Service Manual

CD Stereo System

Model No. **SA-AKX32PH**
SA-AKX32PN
SA-AKX32PR
SA-AKX52EB
SA-AKX52EG
SA-AKX52GN
SA-AKX52PH
SA-AKX52PN
SA-AKX72PH
SA-AKX72PN
SA-AKX92PH

Subject : Updates on Printed Circuit Board, Schematic Diagram, Exploded View,
Parts List & Troubleshooting Guide.

4.1. Cabinet Parts Location - Location B:11 - B:11.

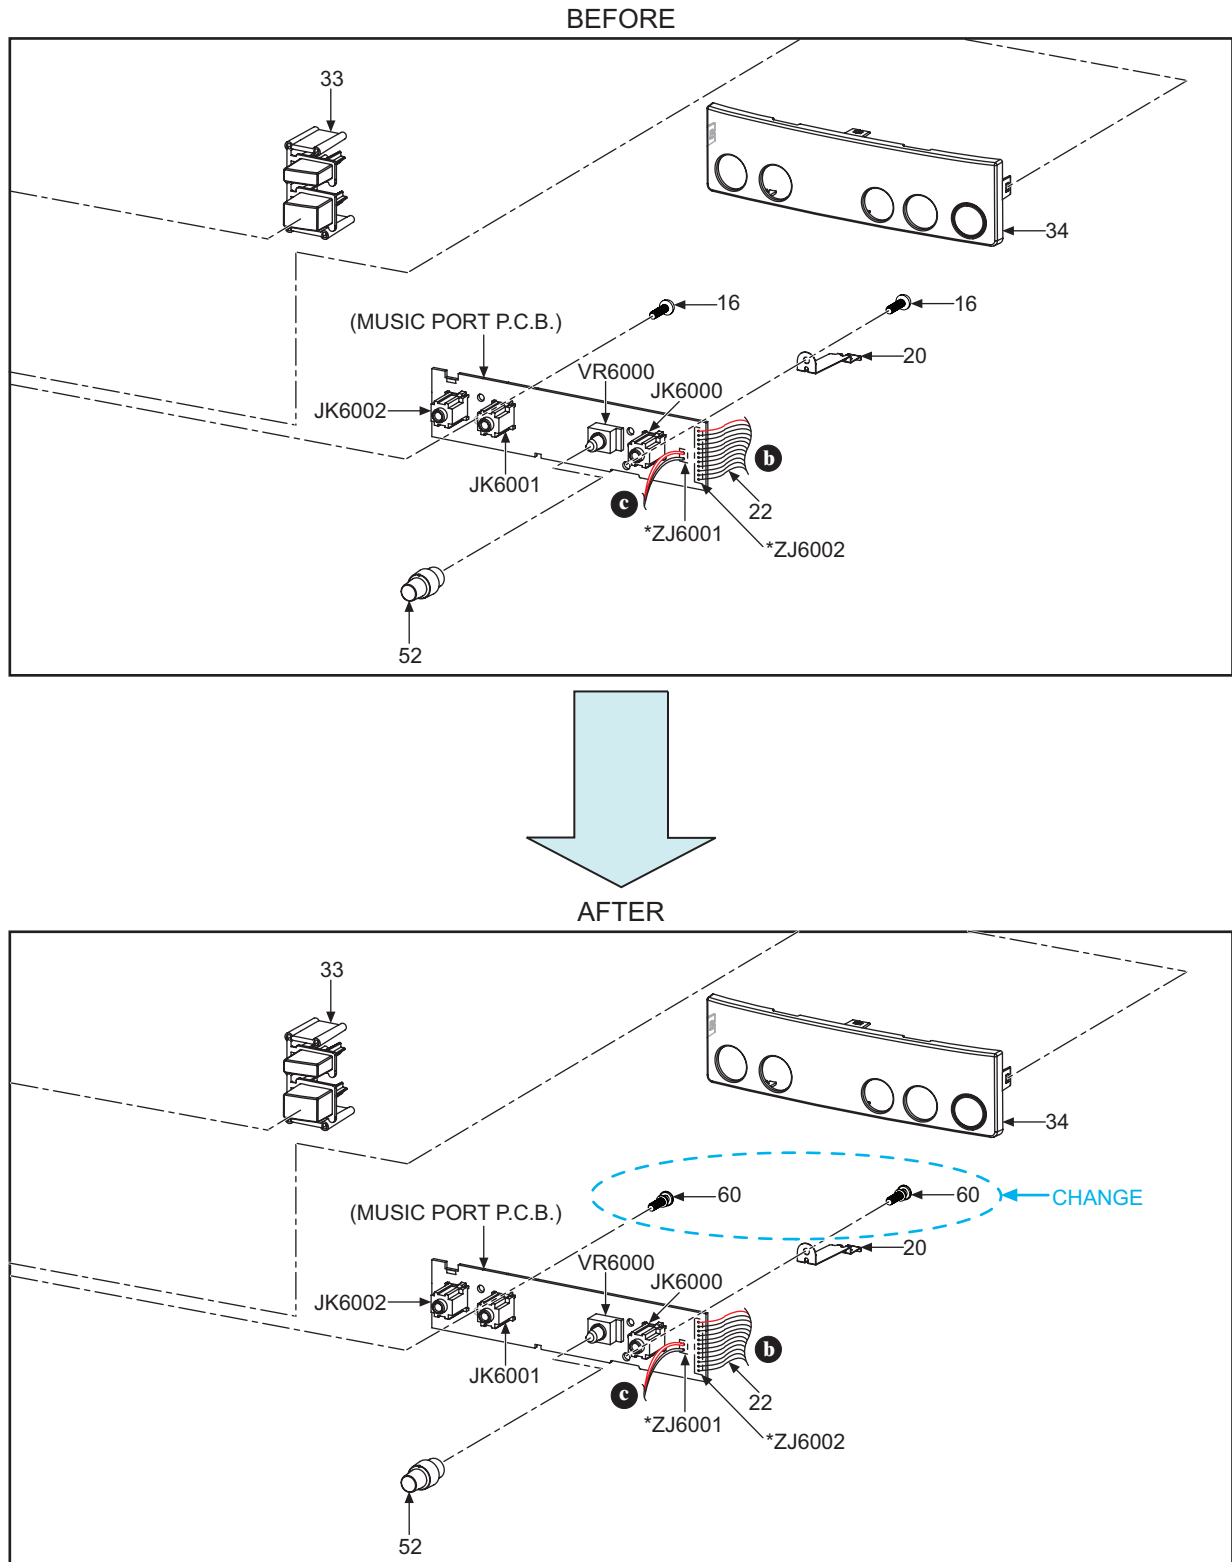
With reference to original service manual (section 20.1.1) on page 123 (SA-AKX32PH/PN-K).
